Response to FERC AIR WQ -5

ADDITIONAL GEOMORPHOLOGY INFORMATION

Klamath Hydroelectric Project
(FERC Project No. 2082)

May 2005

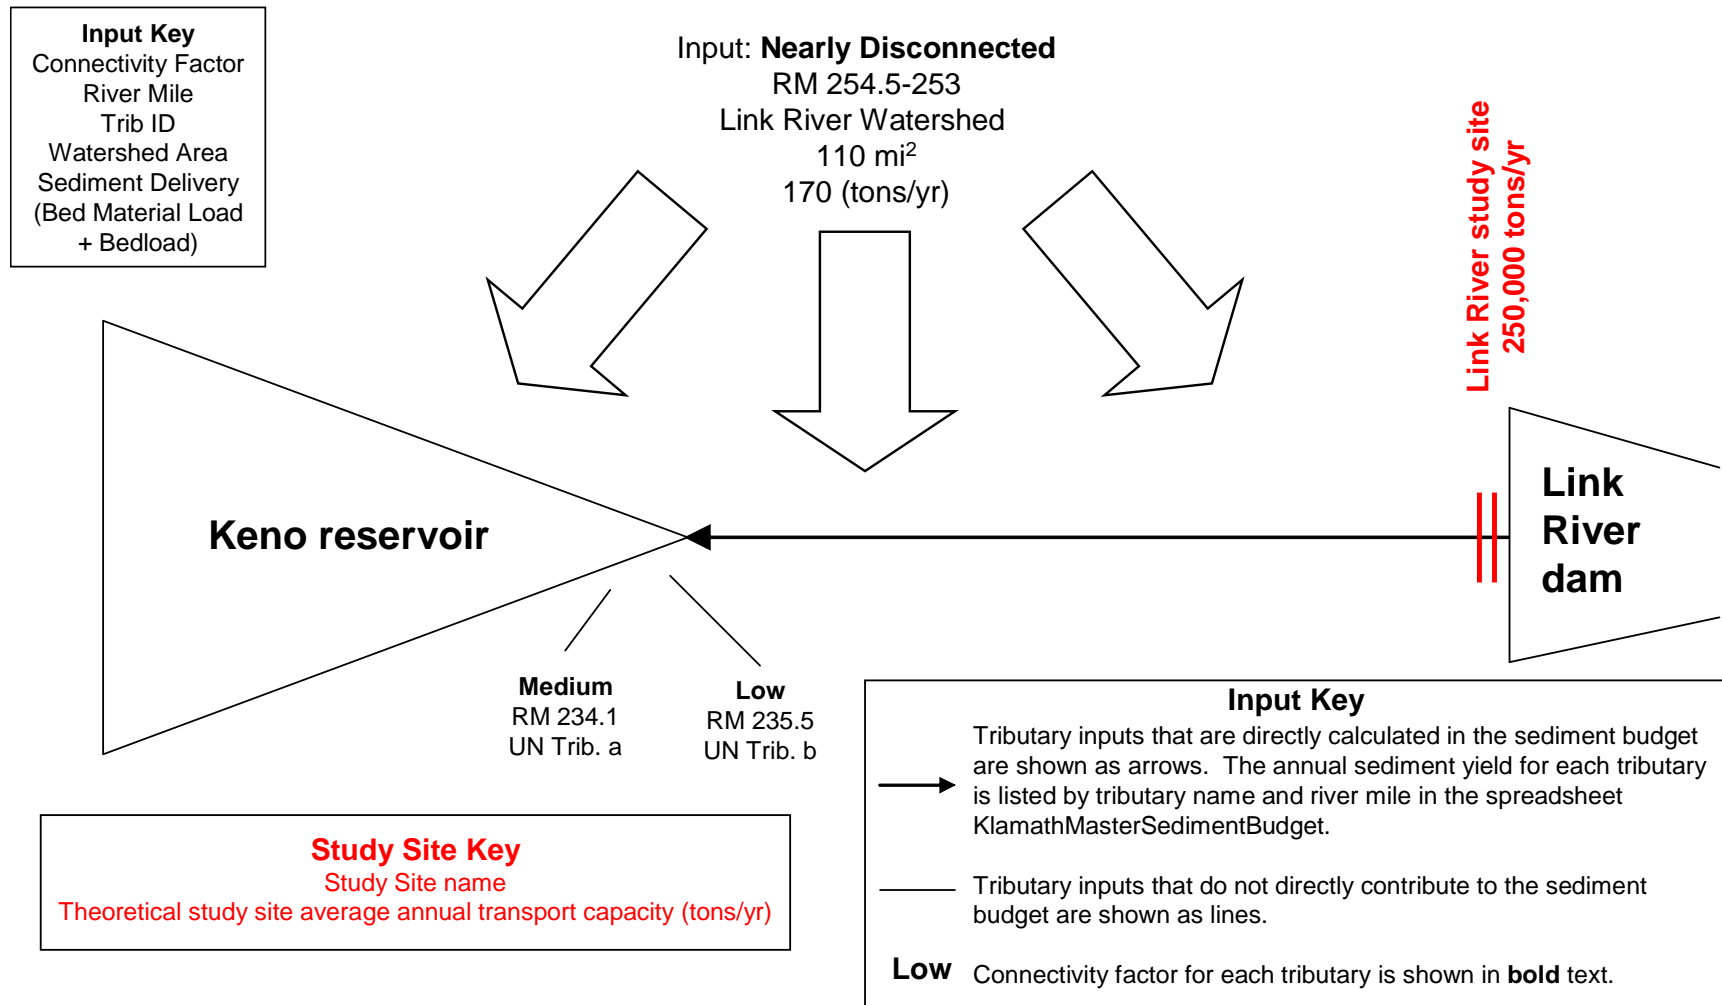
- Modify sediment budget to include feeding of cells from the upstream reaches.
- Provide Excel-format spreadsheets that contain all formulas, data, and results in a modifiable format.
- Ensure sediment flux resulting from floodplain and in-channel storage is factored into each cell of the sediment budget
- Revise Table 6.7-19 and figures 6.7-59 through 6.7-63 to include all “nodes” or “processes” within the sediment budget.
- Provide the total annual volume of sediment contributed by each source/tributary.
- Provide the annual sediment flux for all other sources and sinks in the cell/reach.

As discussed in the Water Resources Final Technical Report (PacifiCorp 2004), the Link River reach is characterized in this sediment budget as a transport reach and, because of Upper Klamath Lake, probably had very low sediment supply prior to the completion of the Project. Few tributaries contribute sediment directly to this reach, and relatively steep slopes result in a high theoretical transport capacity (Figure 1).

The results of the sediment budget for the Link River reach and Keno reservoir indicate that Keno dam causes a potential deficit of approximately 250,000 tons per year of sediment that could be transported to the Keno reach if not for the dam. However, the actual potential deficit is determined by sediment inputs and amounts to only 169 tons per year, because historical transport could not have exceeded supply despite the high transport capacity of this reach. (Note: this and all of the following tributary input values have been adjusted to remove the 20 percent wash load included in the tributary volume results discussed in section 6.7.11 of the Water Resources Final Technical Report (PacifiCorp 2004)). Further, because this sediment would have historically been deposited in Lake Ewauna, there is probably not a significant impact on sediment transport in this reach or the Keno reach downstream. Therefore the cumulative deficit to the downstream reach is 0 tons/year.
